# MEMO

| <b>SUBJECT</b> | History of Harbertonford community traffic concerns raised with Devon County Council |                        |              |

## **A381 Main Road, Harbertonford – Pedestrian Crossing Relocation**

### **Stage 1 Road Safety Audit Response Document**

- Drawing: 70074832-001 Rev P01
- RSA Team Lead Assessment

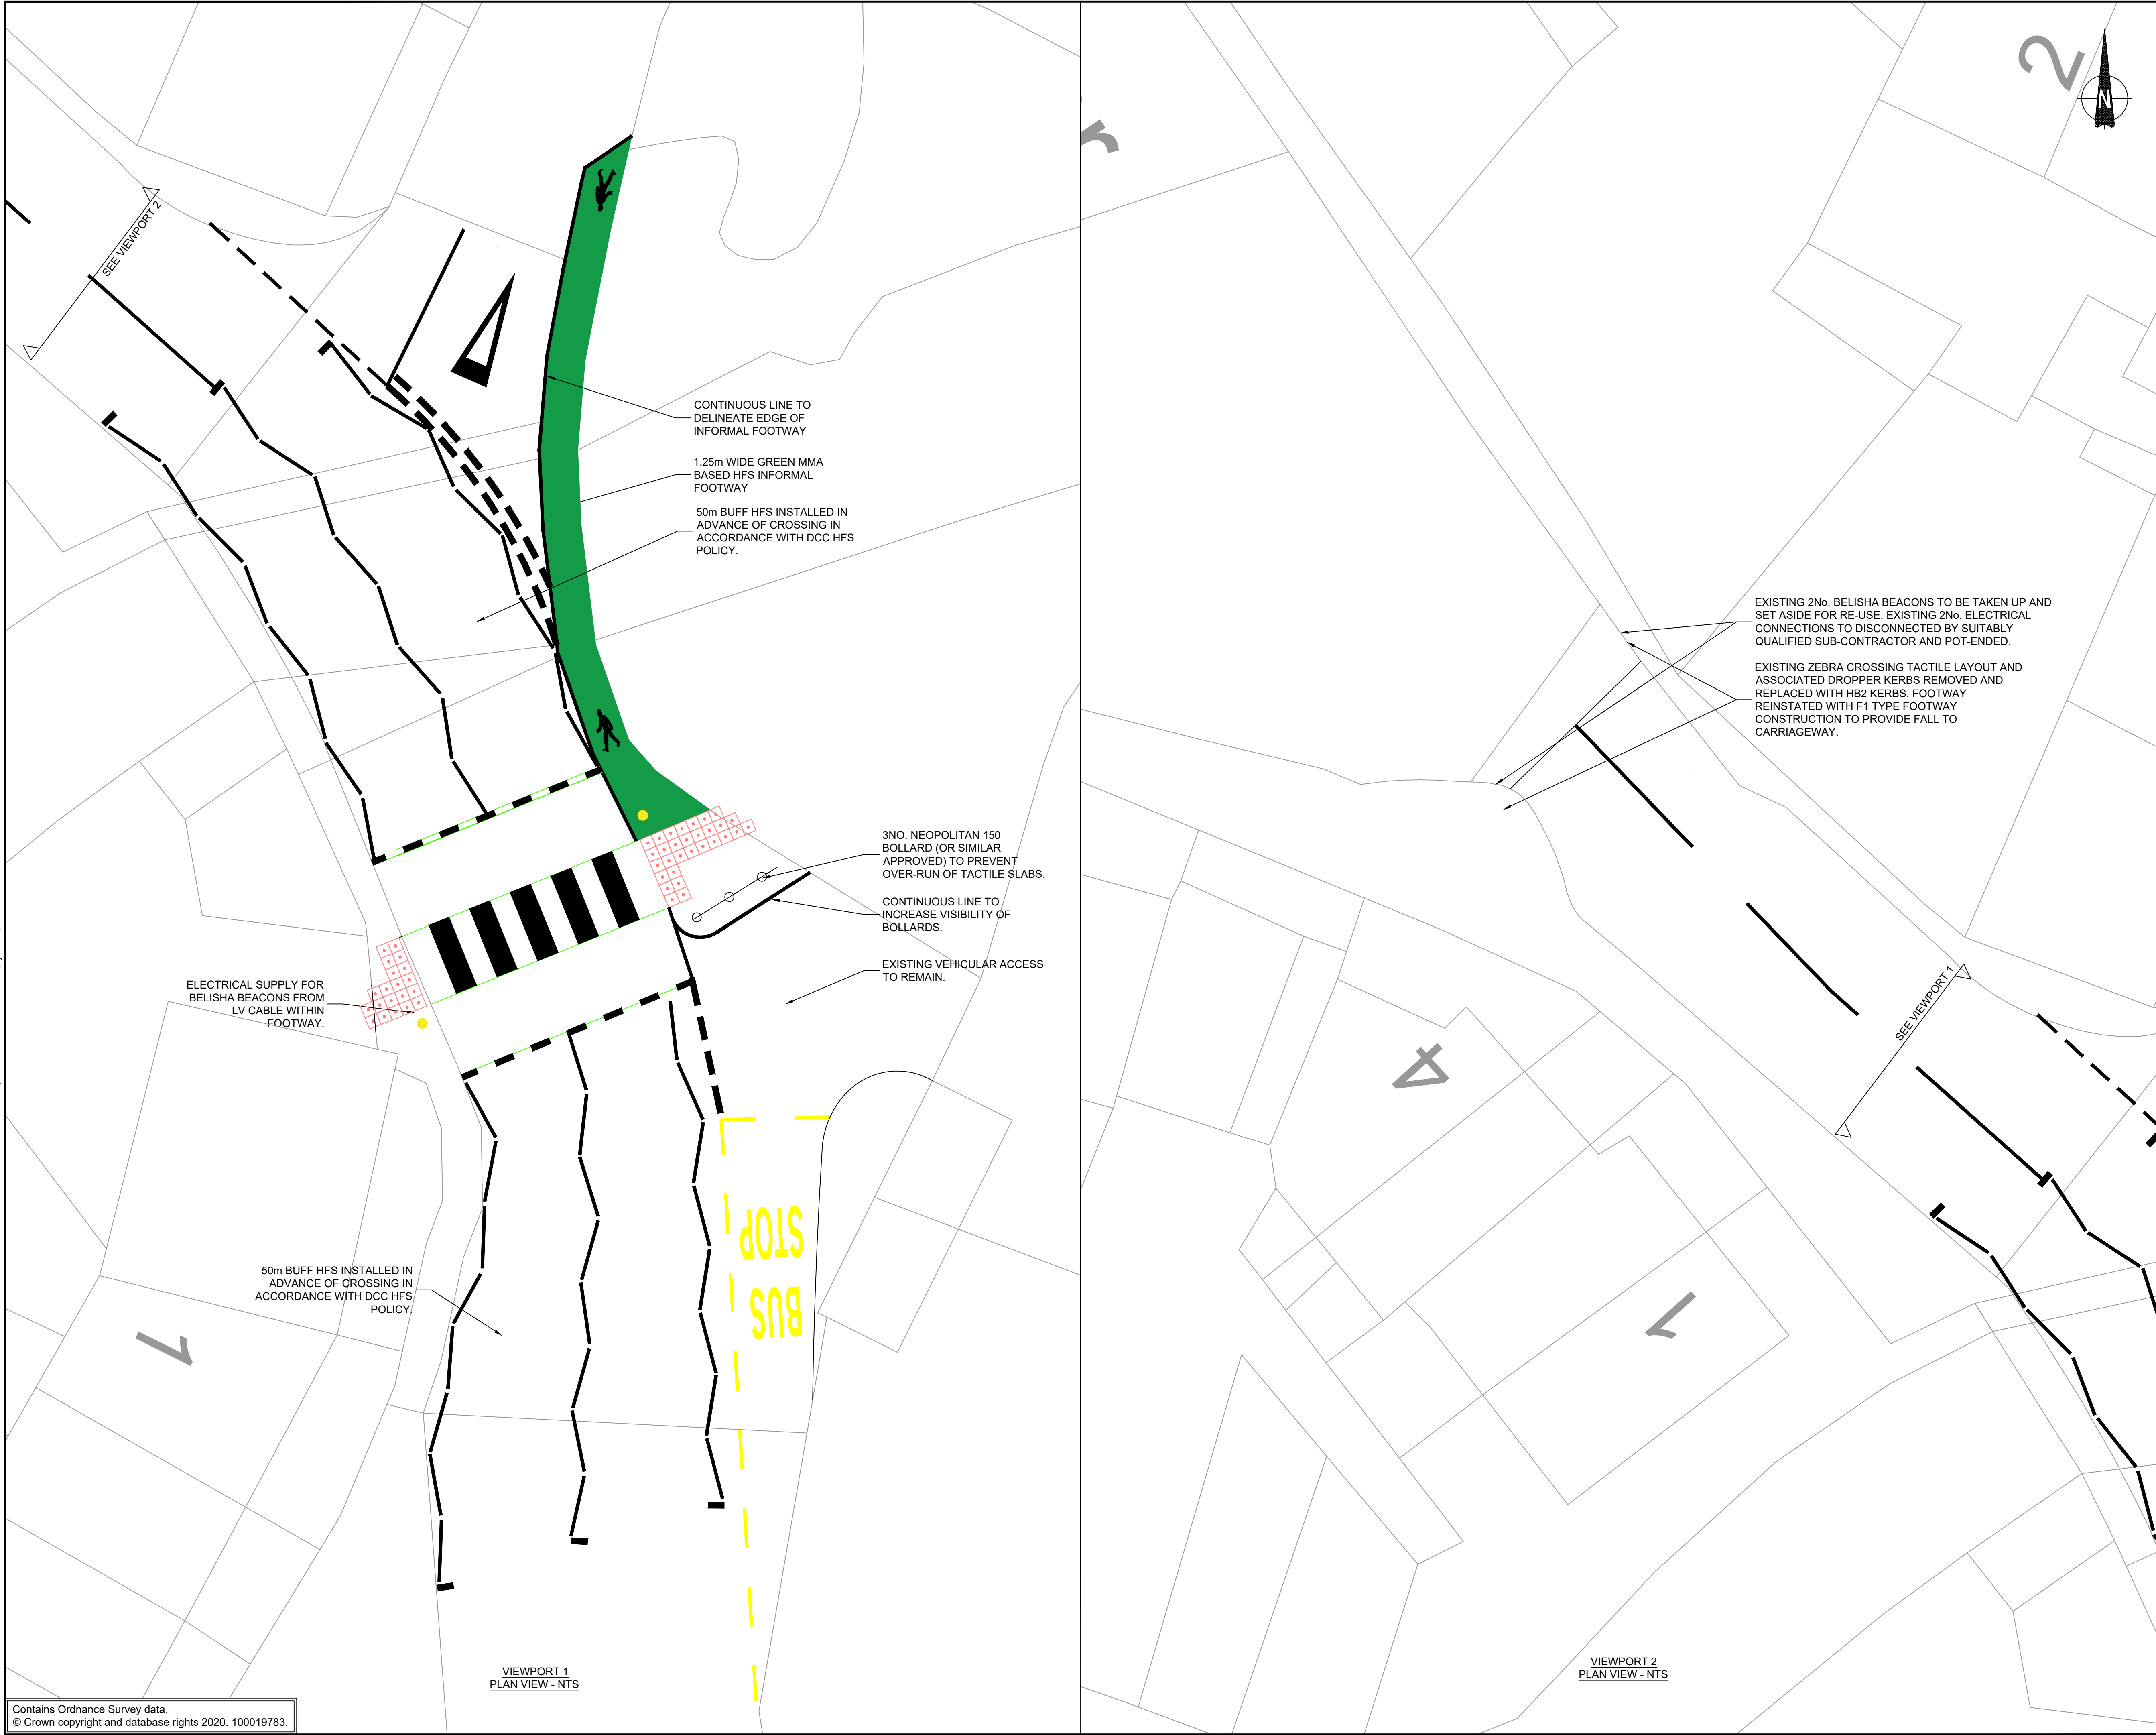
I have been to site and looked at the proposals for the Zebra Crossing in Harbertonford, and in summary suggest that the proposed location is marginally better than the existing location in terms of road safety. Having said that neither location is ideal in terms of road safety and both could probably be considered non-compliant and therefore have road safety risks (but probably better than nothing!) and I have the following initial comments:

1. Has consideration been given to a traffic signal controlled crossing?
2. The visibility north from the west side of the road at the proposed crossing location is poor, particularly for shorter people (see photograph 1), is there anything that can be done about the wall (reduced the stone height and replace with railing?)

3. Visibility for southbound traffic to the new crossing location will be worse than existing (see photograph 2), the nearside beacon will not be visible and only half of the zebra road markings will be visible from a reasonable distance back, measures will need to be considered to improve this.

**Figure 2.31 – Intervisibility from 7.5m bus**

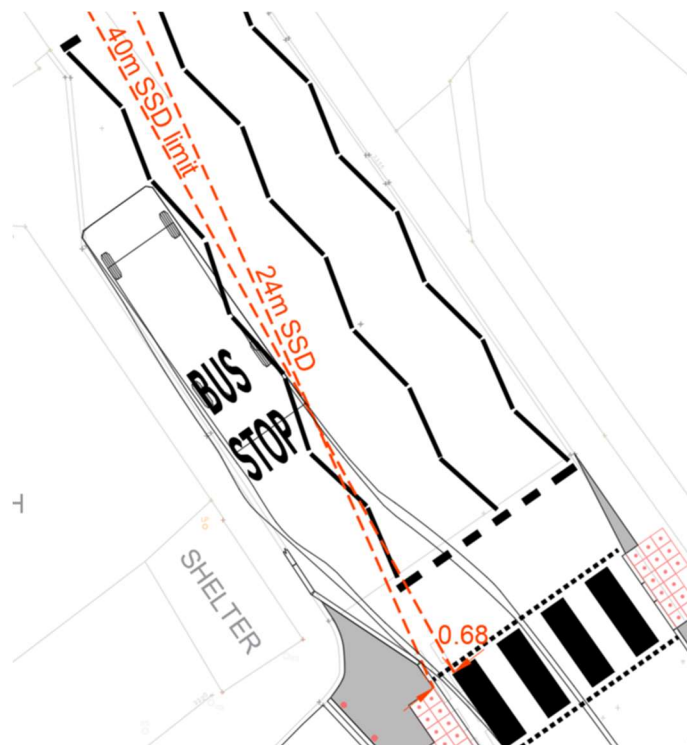
| <b>Summary</b>        | A bus stopped at the bus stop could reduce intervisibility between pedestrians and southbound vehicles.   |
| <b>Description</b>    | A new buildout is proposed in the bell mouth of Woodlands Road to provide a zebra crossing and a bus stop lay-by. The bus stop lay-by is proposed to be 11m long at the back of the lay-by, 19m long along the front of the lay-by and approximately 2m wide. Swept vehicle path analysis provided to the Road Safety Audit team shows that a double decker bus would be unable to stop in the lay-by without obstructing the northbound mainline carriageway. This would reduce intervisibility between pedestrians at the western crossing point and southbound vehicles on the A381 to approximately 11m. This could increase the risk of a pedestrian stepping into the carriageway from behind a stationary bus and walking into the path of a southbound vehicle. |
| <b>Recommendation</b> | It is recommended that the bus stop should be repositioned to ensure that suitable visibility is provided from/to the crossing points. The intervisibility provided should be as per the requirement for the 85 <sup>th</sup> percentile approach speed of southbound vehicles in line with DMRB document CD 143.   |

It is agreed that intervisibility to the crossing is impaired between pedestrians on the west side of the crossing and vehicles travelling southbound when a bus is at the stop.

A lay by that could fully accommodate the width of a bus was considered, however due to the limited length between the junction of Woodlands Road and the watercourse to the north that runs along the east extent of the church, a suitable depth lay by with taper on the approach and exit could not be achieved that would enable a bus to use this as intended.

It was therefore considered that having a crossing with limited periods of impaired intervisibility is considered less of a risk than the permanent restricted visibility of the existing crossing.

The existing crossing requires at all times for pedestrians to step in front of live traffic to activate the crossing which has a restricted visibility of 23m where a 40m stopping sight distance is required.

The proposed crossing will provide at least 40m stopping sight distance for vehicles in both directions in normal traffic when the bus stop is not in use.

The bus stop is currently and primarily used by a 7.5m hopper bus service. If the bus is still stopped at the bus stop when pedestrians wish to cross from the west to the east side, visibility to southbound vehicles is restricted temporarily by the bus to approximately 24m. However, the significant difference is that pedestrians would not be stepping in front of a vehicles path with a stopping sight distance of less than 40m. A pedestrian crossing from the west side would activate the crossing by stepping into the crossing in front of north bound vehicles that will have an SSD of at least 40m. At approximately 0.7m into the crossing, still within the north bound lane and protection of the bus at the stop, visibility for south bound vehicles will improve to 40m before continuing into the southbound lane.
